## Product Change Notification

TRIMPOT® TRIMMING POTENTIOMETERS

### Bourns® Trimpot® Product Line Announces Product Change for Model 3313

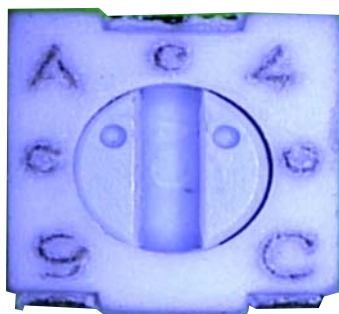
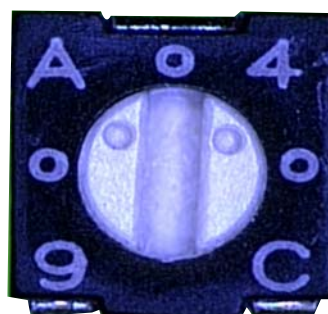
Bourns® Trimpot® Product Line has updated the housing material for the Bourns® [Model 3313](#). This improved housing material is now halogen free\*\*. There is no change to form (except color), fit or function. The halogen free material will come in a black color. A benefit of this color change is an enhanced contrast in marking.

**We will begin phasing in this material on April 1, 2012.**

- The effective date code will read 2E.
- The expected last date of manufacture of the current product is April 15, 2012.
